ADDENDUM # 2

Concerning the **"PSJA ISD AGRICULTURAL FACILITY PHASE I BID # 18-19-003"** to be opened at 4:00p.m., Thursday, OCTOBER 4, 2018. Please consider the following:

**ADDENDUM NUMBER TWO (2)
TO THE PLANS AND SPECIFICATIONS FOR:**

**PSJA Agricultural Facility – Phase I
PSJA ISD
Bid #
Project No. 16.08**

SK-1

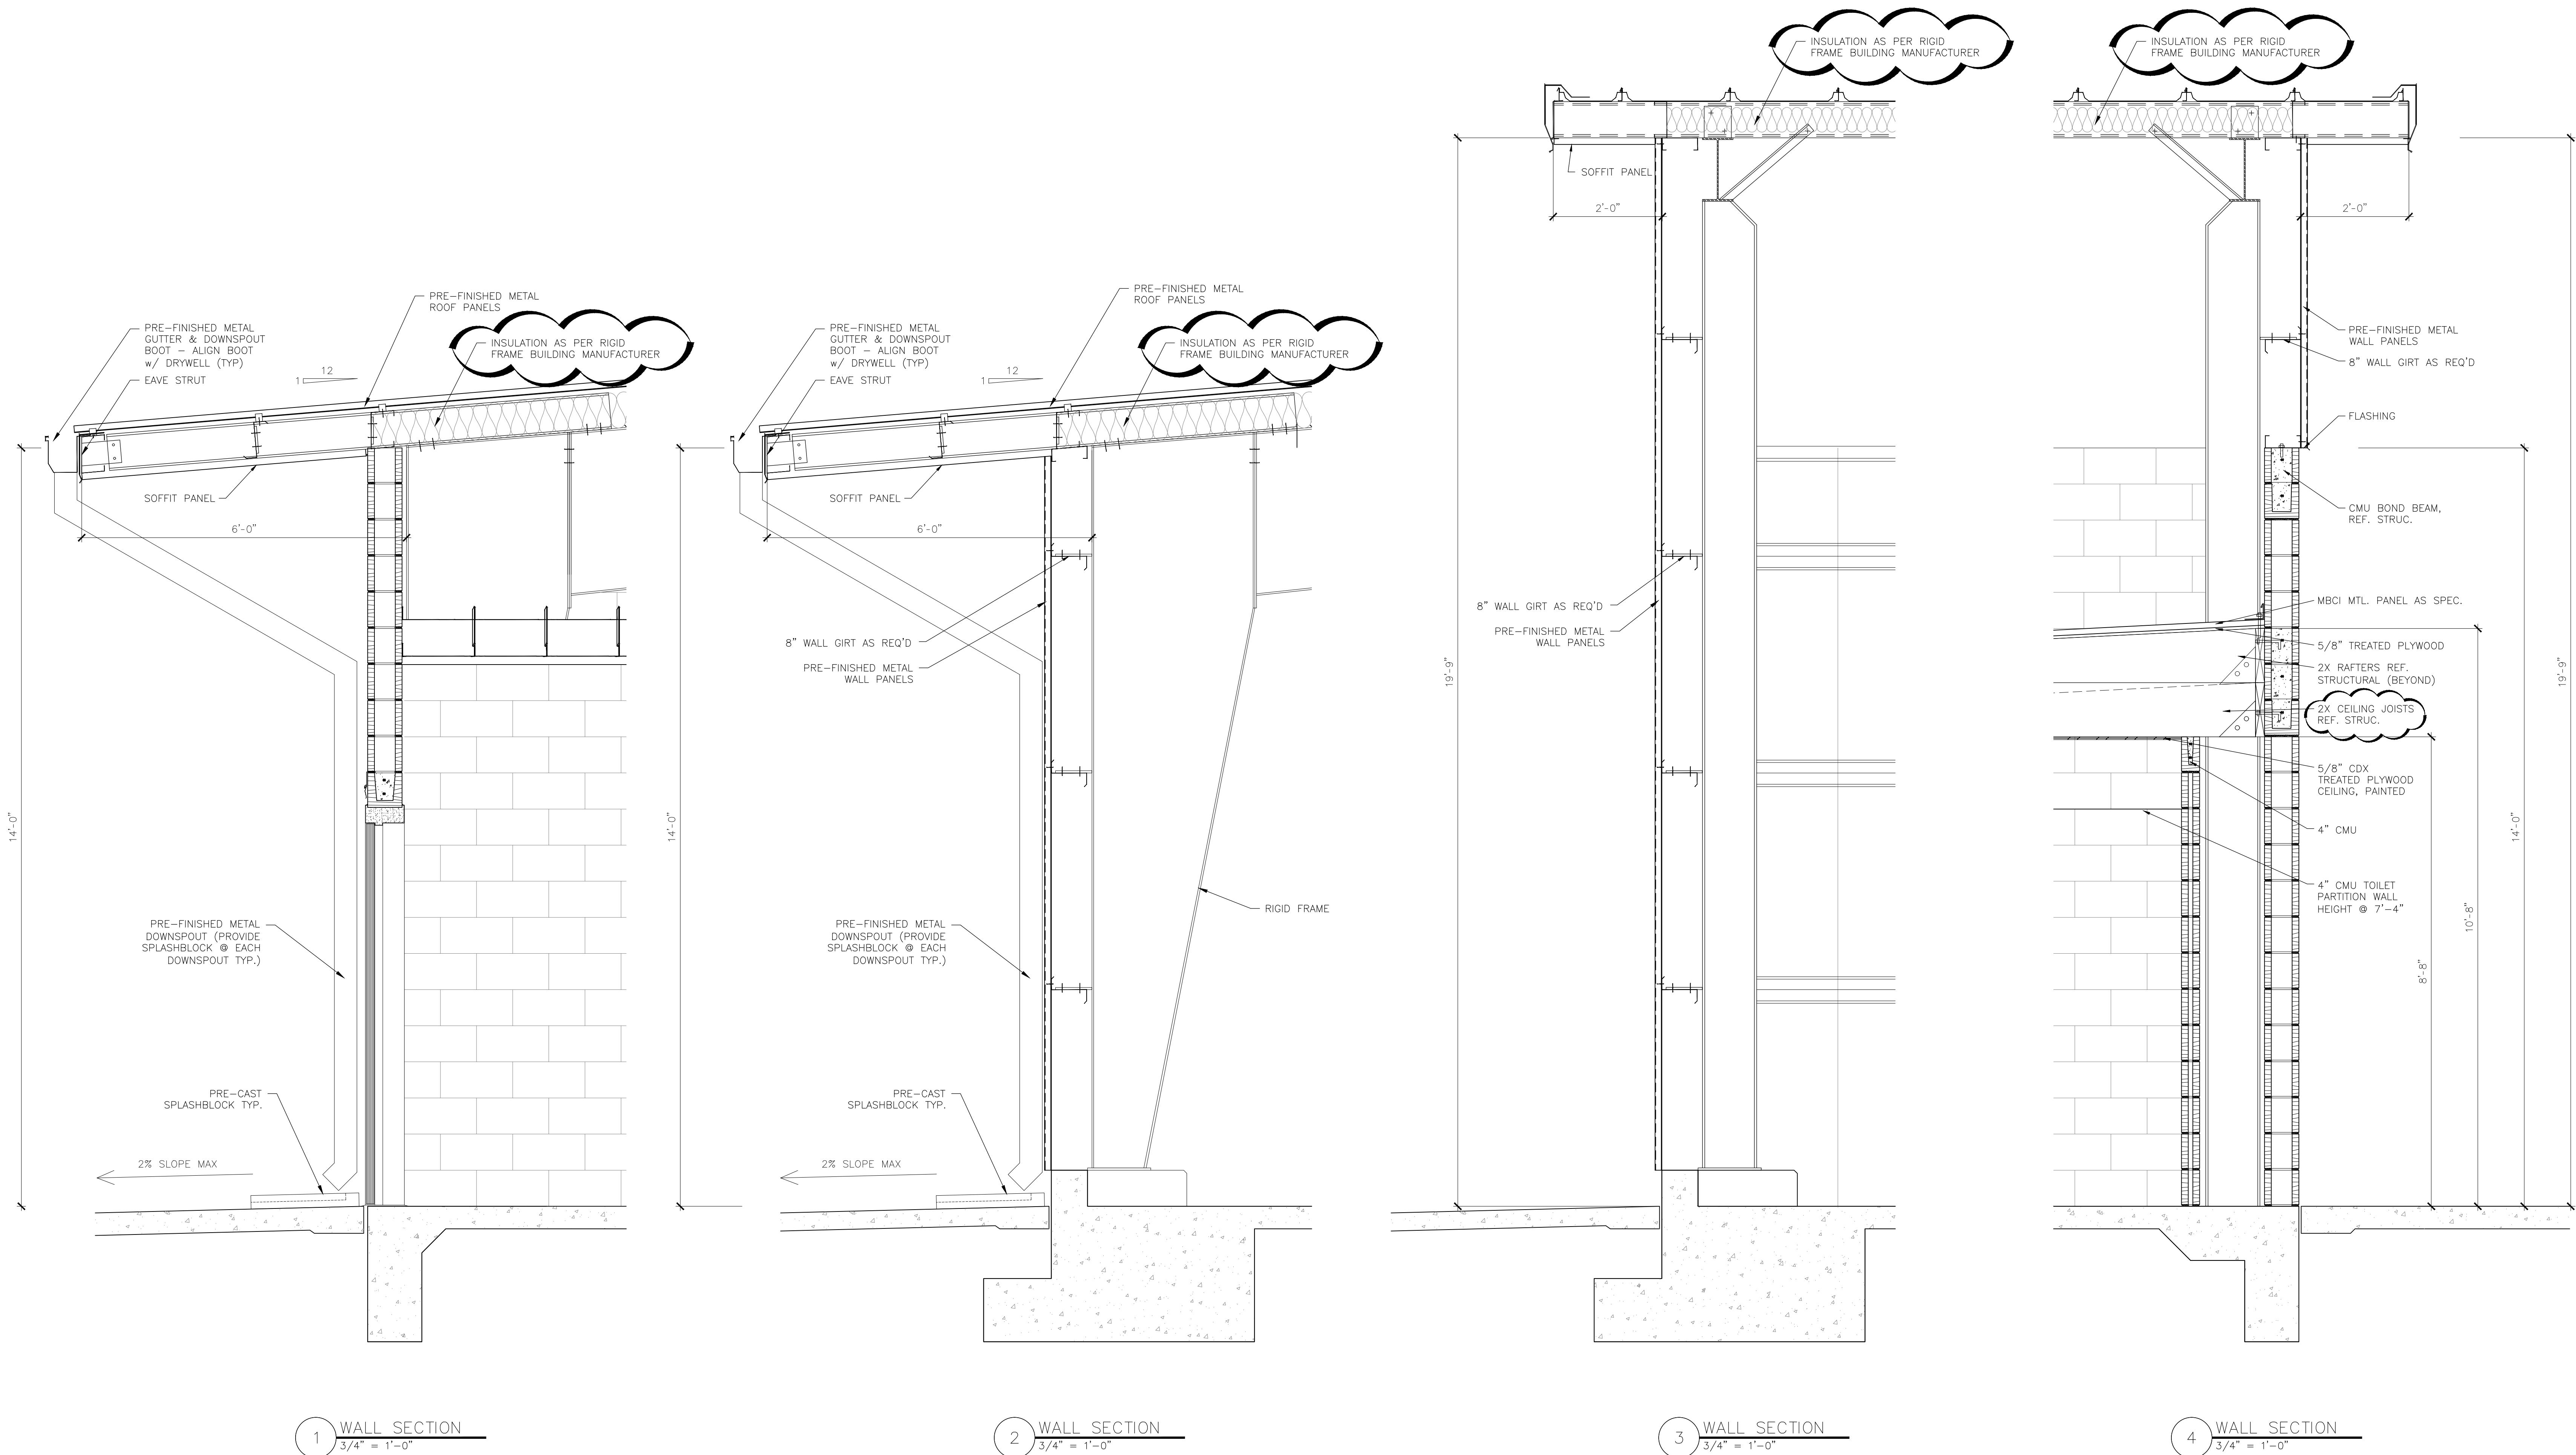
RFI: for architect. See attached sheet A101 detail 7 & 8 provide detail of storage units or spec for units. Units is millwork or metal?

Refer to Section 064113 in Project Manual for storage locker's specifications. Please refer to attached drawing for detail of storage lockers.

A-301

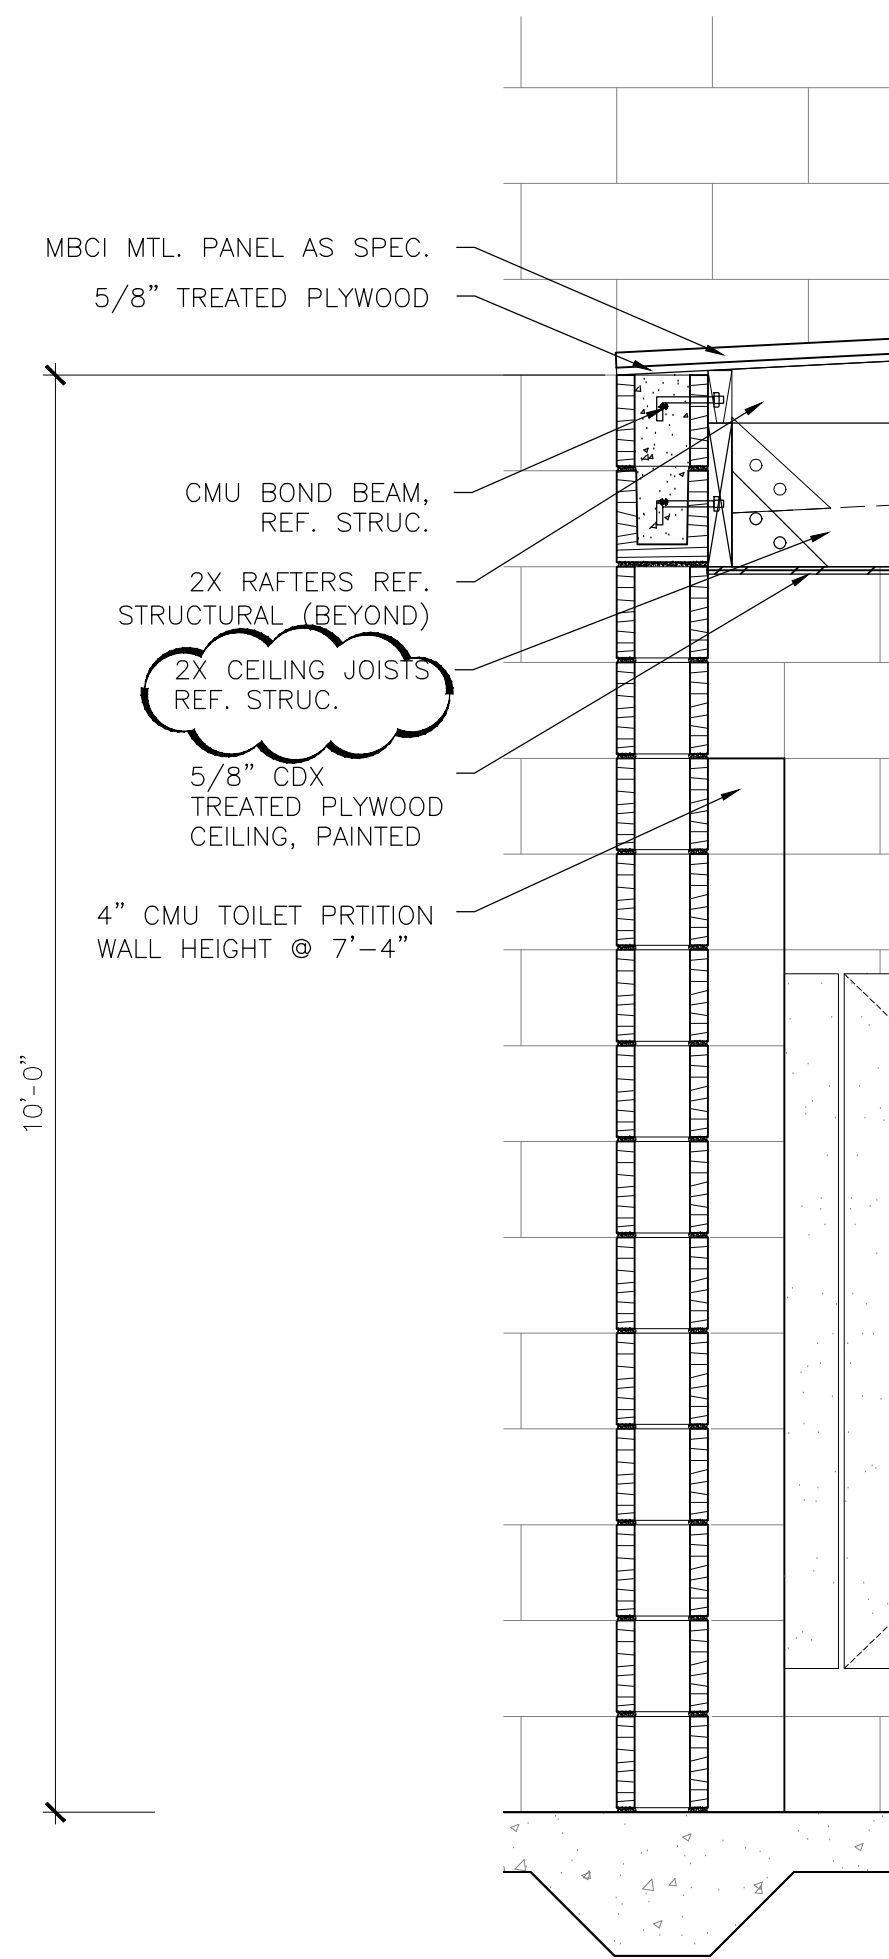
RFI: If the roof panel is not an insulated metal panel, please confirm the use of blanket insulation, thickness, and type (ie..banded system)

RFI: for architect or engineer. Architectural plan sheet A3.02 shows 2x12 wood studs, but on structural sheet S4.2 shows something different. Please verify/clarify.

Refer to reissued sheet A-301 & sheet A-302 for clarification.

Refer to reissued sheets A-301 & A-302 for clarification, detail now reads to refer to Structural.
